Traffic Impact S

Flats on  
Aurora, (

Comments: 02/10/2021

## **Flats on the A at Gateway park**

FIGURE 10

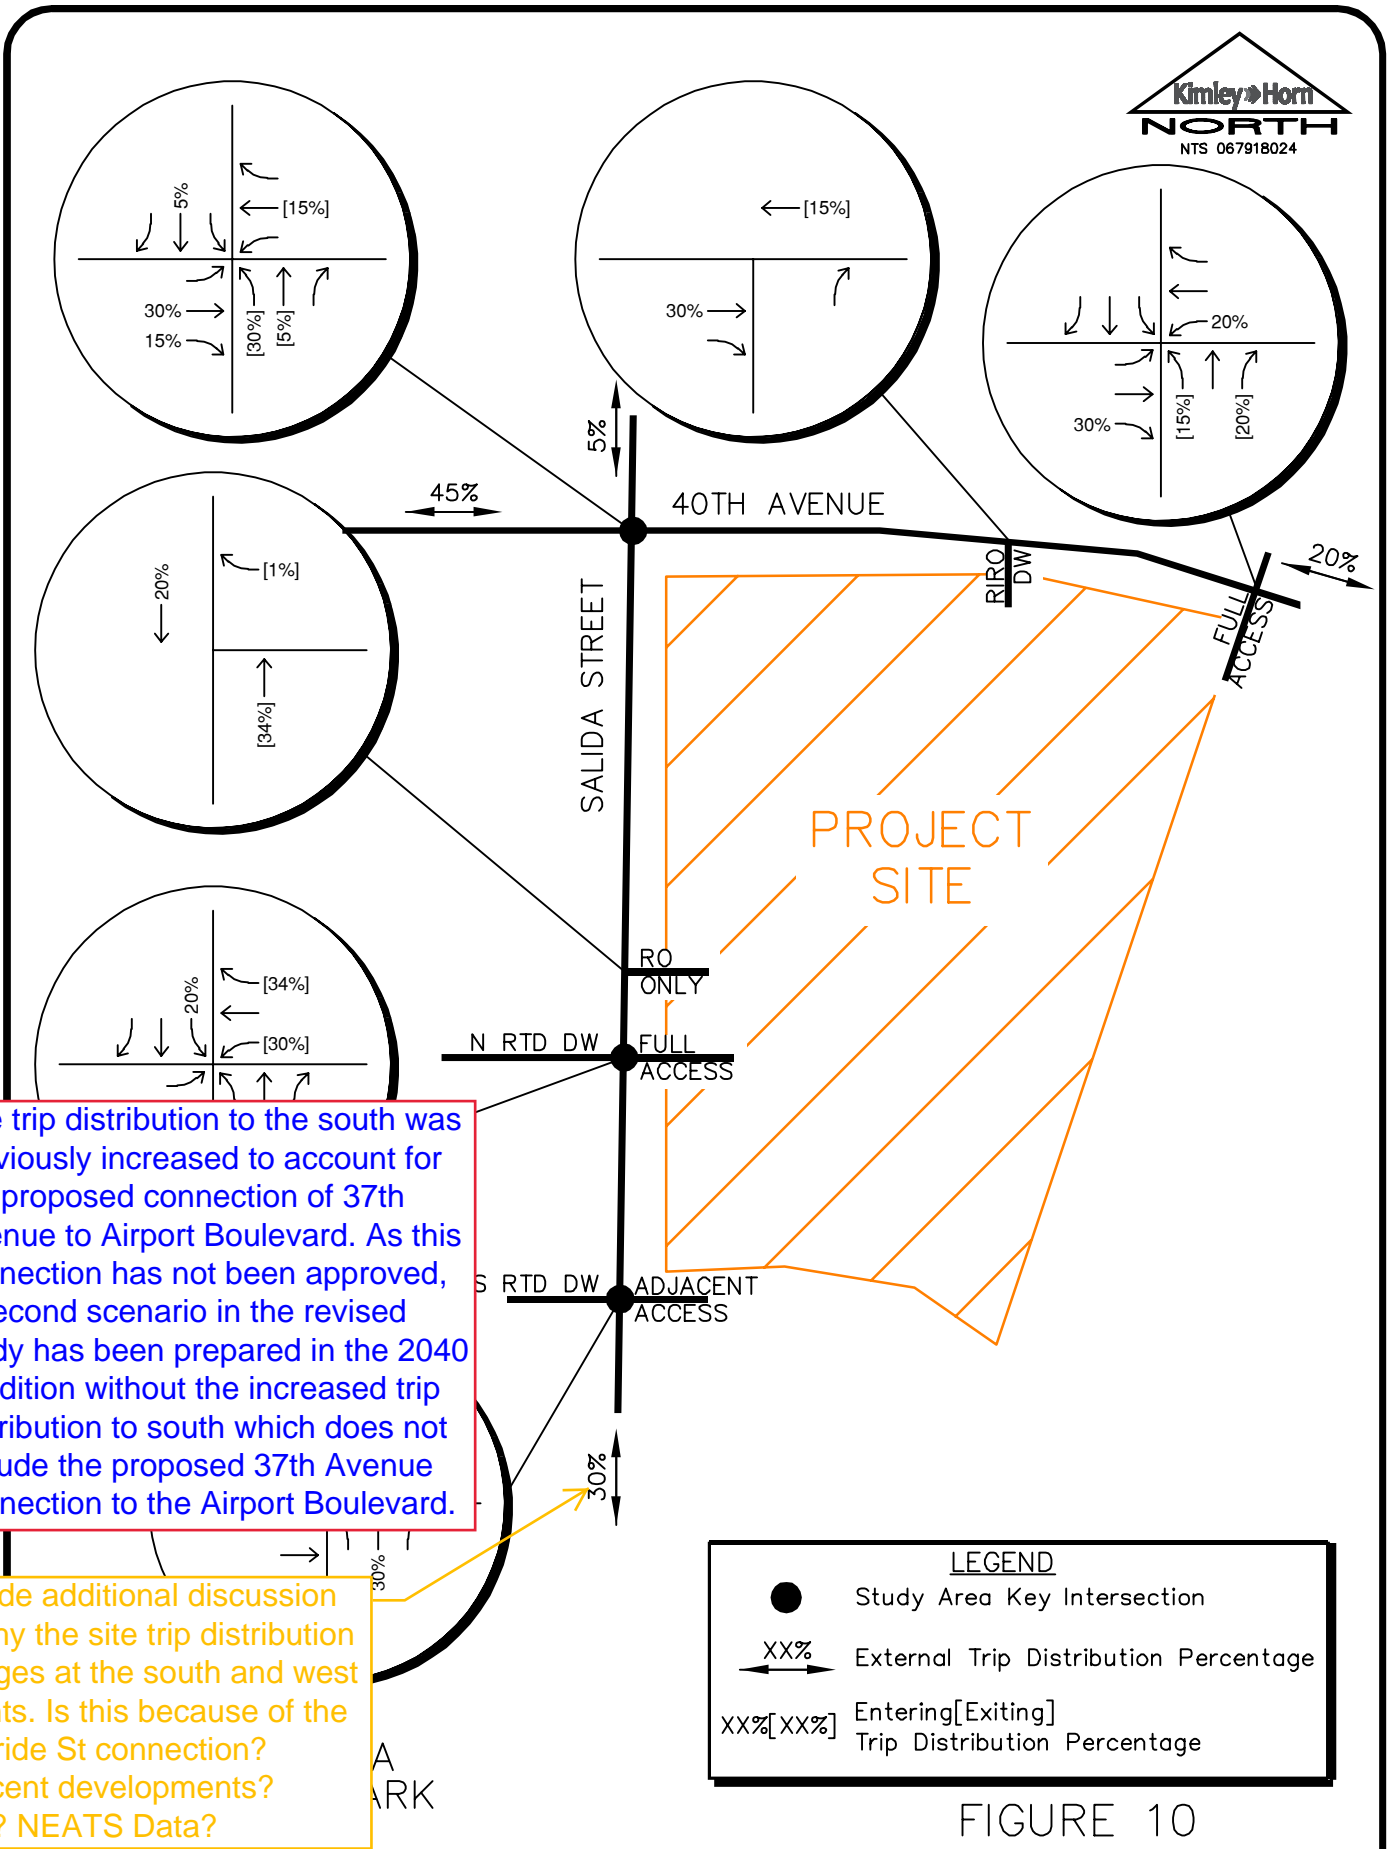
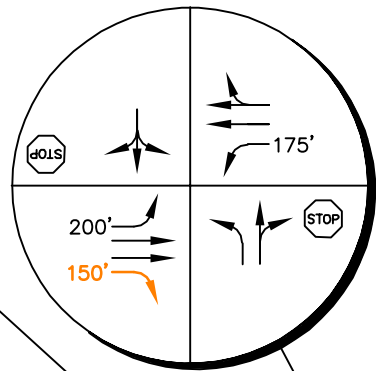
Provide additional discussion on why the site trip distribution changes at the south and west extents. Is this because of the Telluride St connection? Adjacent developments? Both? NEATS Data?

The trip distribution to the south was previously increased to account for the proposed connection of 37th Avenue to Airport Boulevard. As this connection has not been approved, a second scenario in the revised study has been prepared in the 2040 condition without the increased trip distribution to south which does not include the proposed 37th Avenue connection to the Airport Boulevard.

FIGURE 16

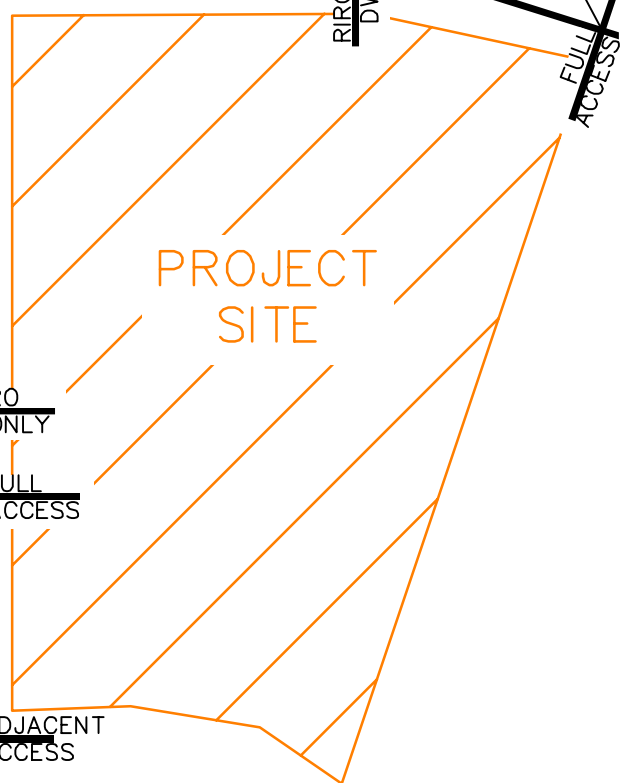
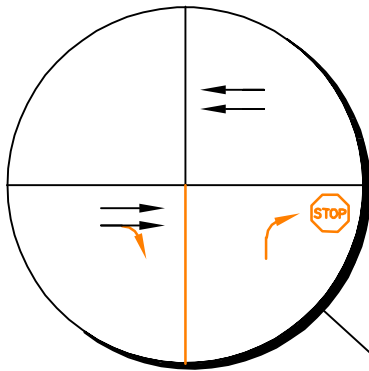
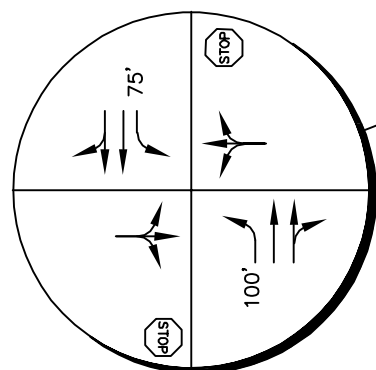
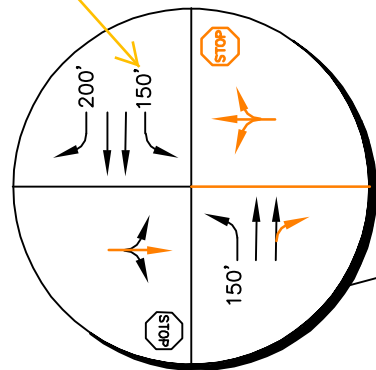
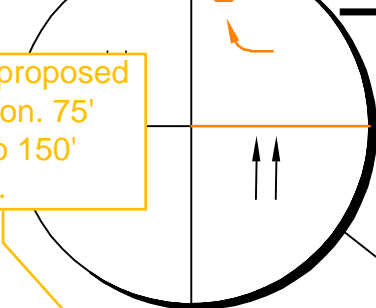
Show as proposed modification. 75' existing to 150' proposed.

Existing length and future length recommendations have been modified for the southbound left turn lane at the full movement access along Salida Street.
